DESIGN RECOMMENDATION MEETING

DPD #3007896

5343 TALLMAN AVE. NW

BUILDING PLANS
LEVEL P2 + P1

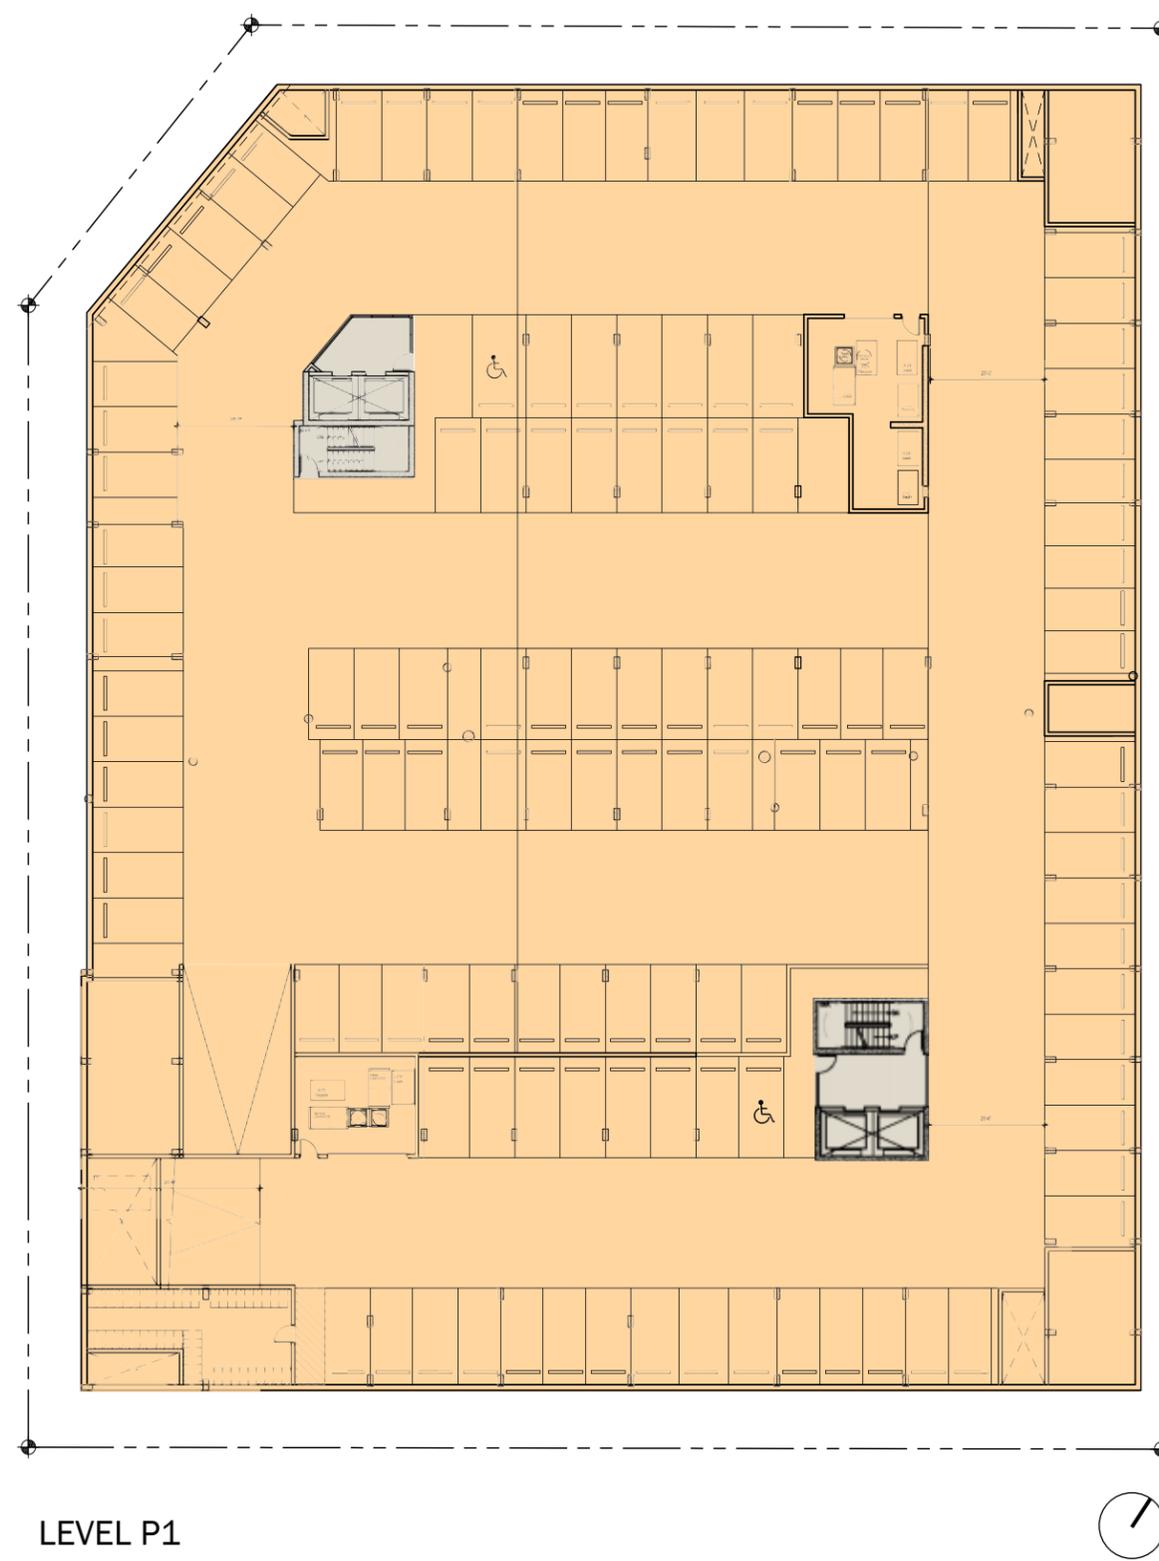
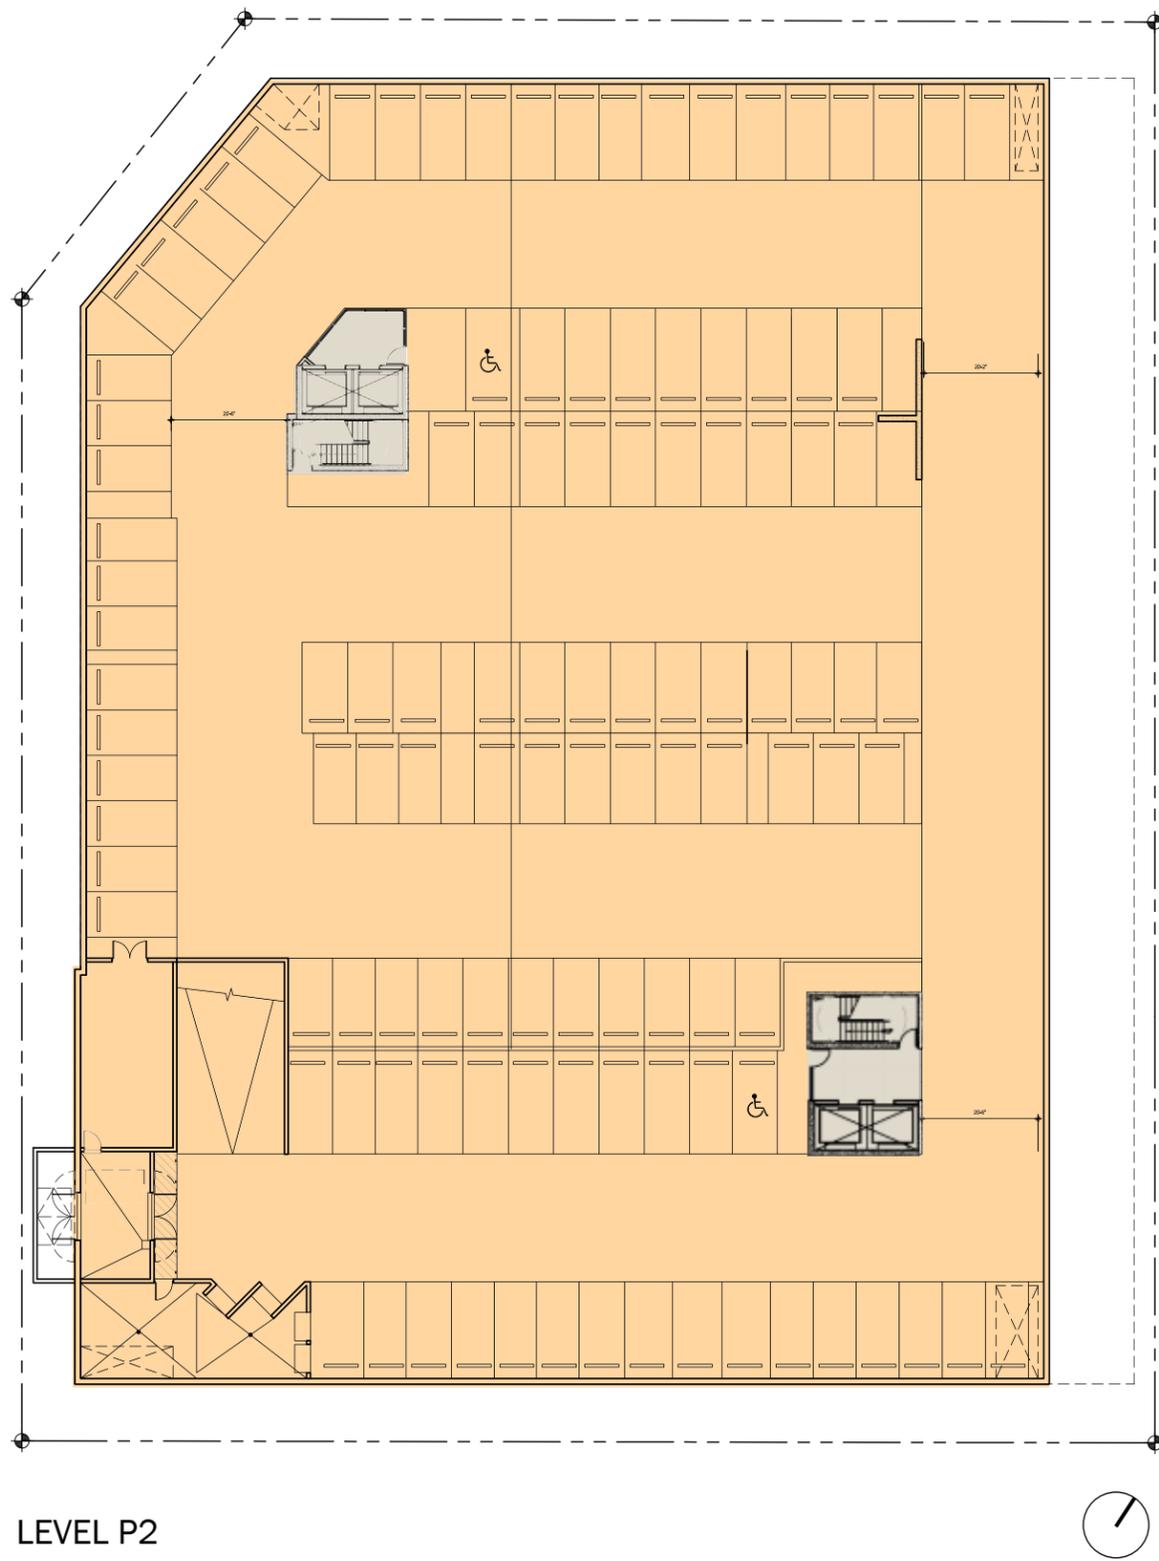
At the Early Design Guidance Meeting, the Board strongly agreed that garage entrances should be minimized and the pedestrian streetscape given priority over the interruption of the pedestrian environment by the driveway. The Board also suggested that the design of the garage doors be carefully considered to provide visual interest at the sidewalk level.

We have omitted one of the original entrances and now only have one at the south end of Russell Ave.

The proposed garage entry is adjacent to the existing garage on the Swedish Medical property to the south. The grades on the site and ramp design would be problematic if accessed from Tallman because the grade is 7' higher. There is also a concern of increasing the traffic level on Tallman Ave. given the existing uses and emergency vehicle access to the medical center.

COURTYARD COMPARISONS

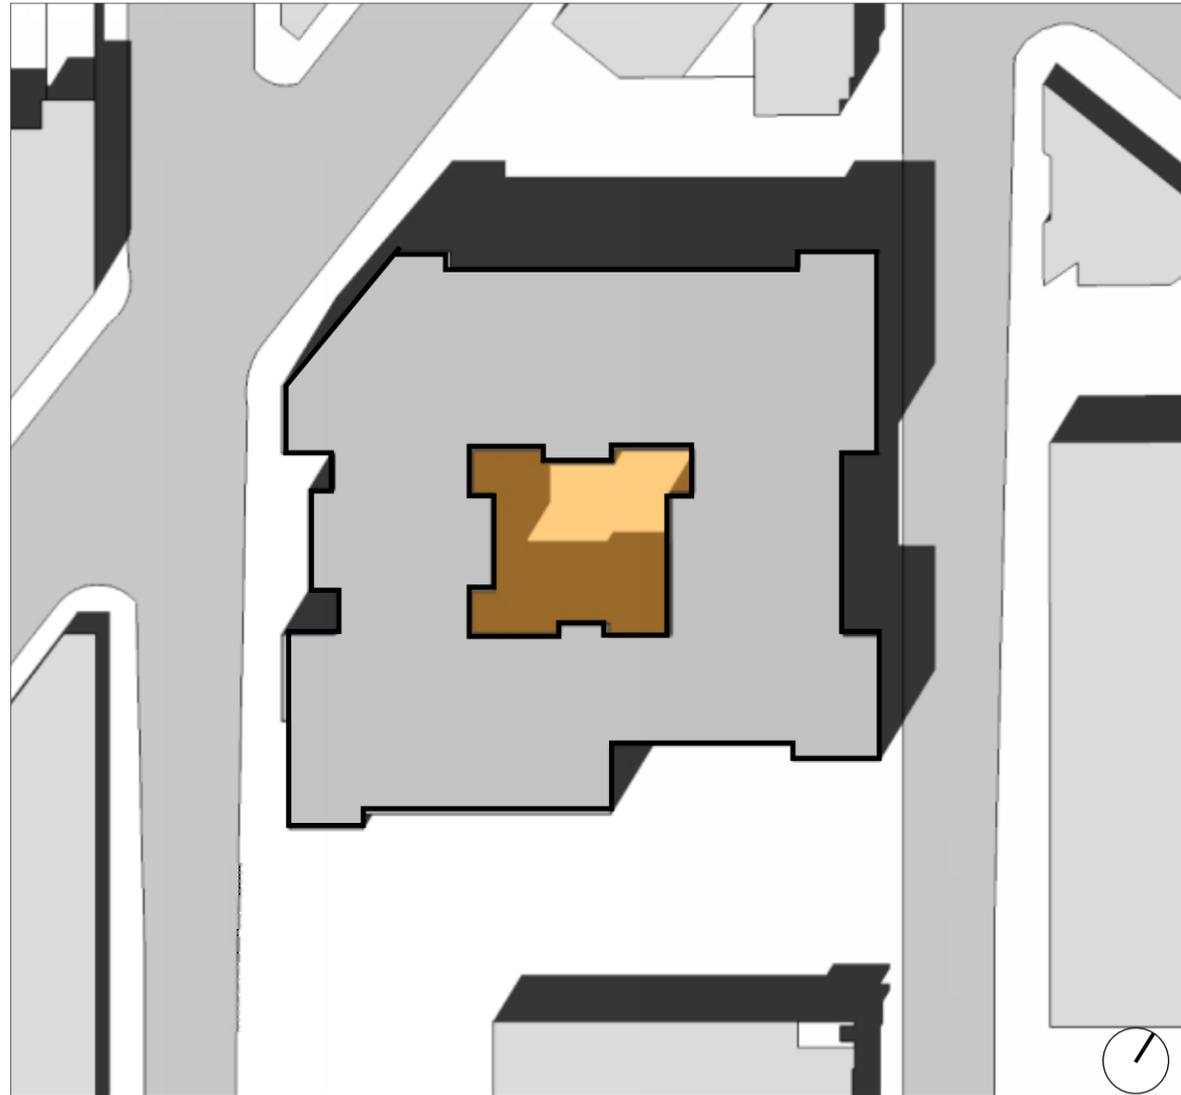
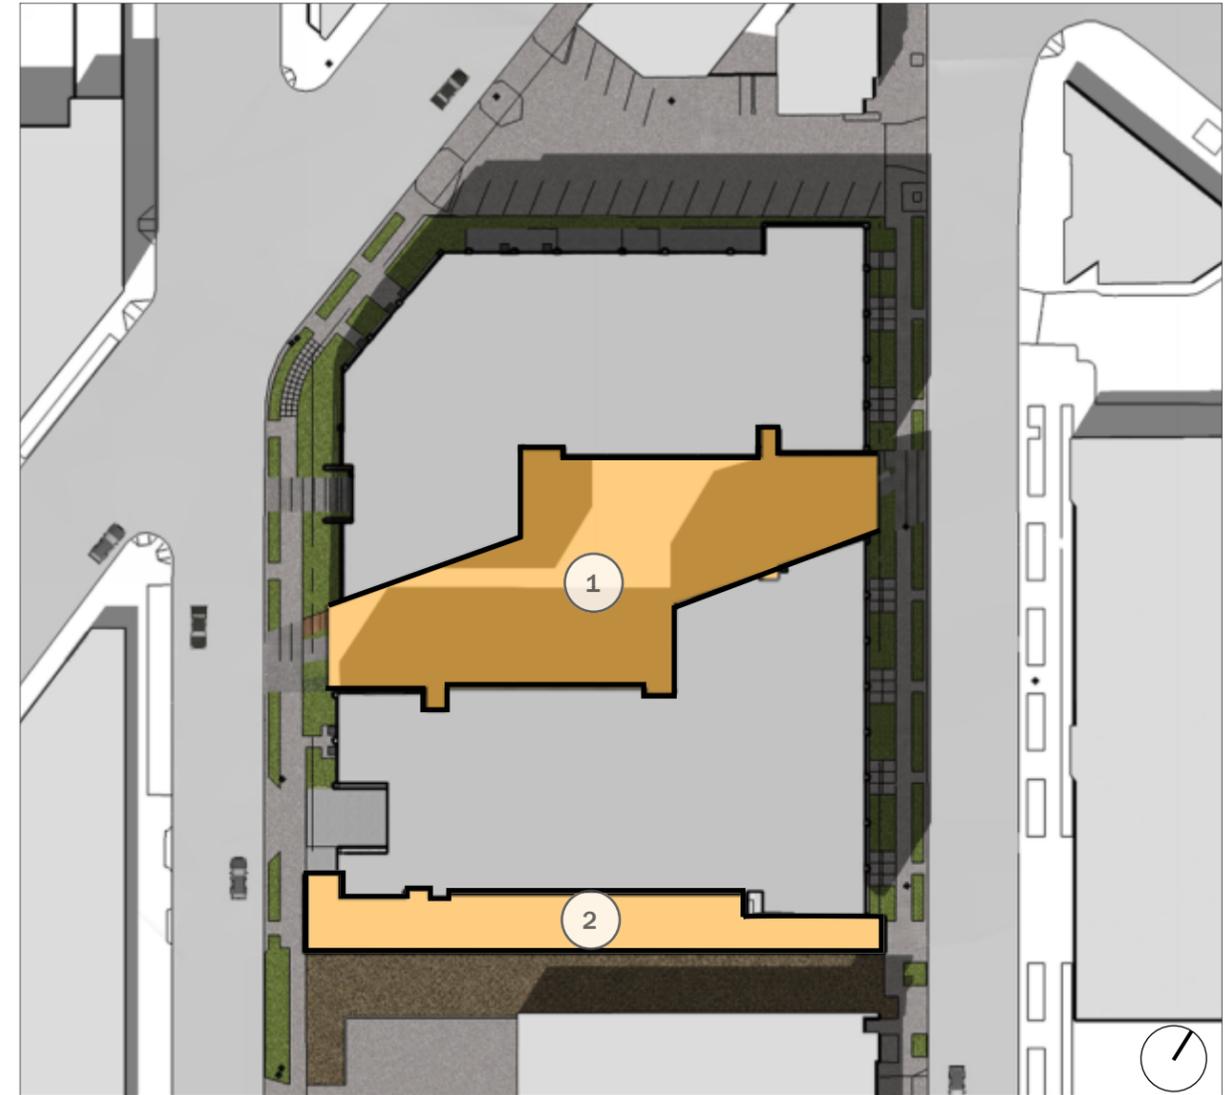
At the Early Design Guidance Meeting, the Board discussed at length the building massing and how it could maximize light access to the residential units. The Board agreed that the design should acknowledge and maximize solar access, including the possibility of exploring differing building heights to allow greater light into the courtyard.

The building is organized around a courtyard, we have added a connecting mews between the courtyard and Russell and Tallman Avenues. This revision has significantly increased the amount of open space at the center of the site which will maximize solar access to the residential units. The building is also stepped down at the southwest side of the courtyard.

① COURTYARD | MEWS = 9780 sf (20% of Site Area)

② SOUTH WALKWAY = 1825 sf (3.7 % of Site Area)

A COURTYARD ENTRY FROM RUSSELL AVE.

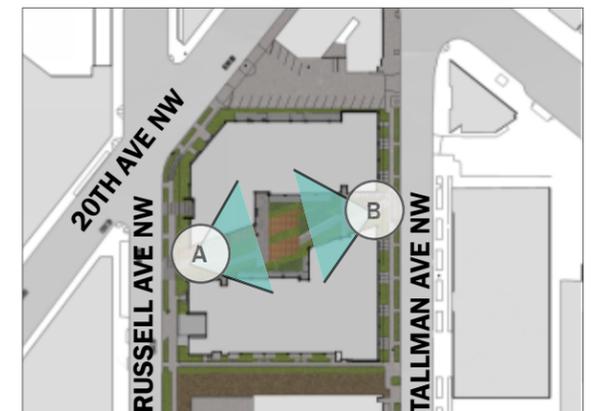
At the Early Design Guidance Meeting, the Board expressed interest in landscaped open space that is located at ground level at entry locations and along the street front that is visible to pedestrians. The Board was very supportive and interested in the through-block pathway along the north side and the 15-foot setback area for the live/work units along the south edge. The Board encouraged that these areas be well lit for safety. The Board also suggested exploration of a pathway design that cuts through the site using the courtyard open space.

A-1, B-1, D-1
VISIBLE CONNECTION THROUGH COURTYARD
MAXIMIZES SOLAR ACCESS AND ACTIVATES THE
PEDESTRIAN ENVIRONMENT

A-4, D-1
PATHWAY (MEWS) ADDED CONNECTING
COURTYARD TO RUSSELL AND TALLMAN. THE
AVERAGE WIDTH OF THE MEWS IS 40' THIS
THROUGH BLOCK CONNECT IS DESIGNED ALONG
A NATURAL PATH (FROM MARKET TO THE CENTER
OF THE HISTORICAL BALLARD DISTRICT).
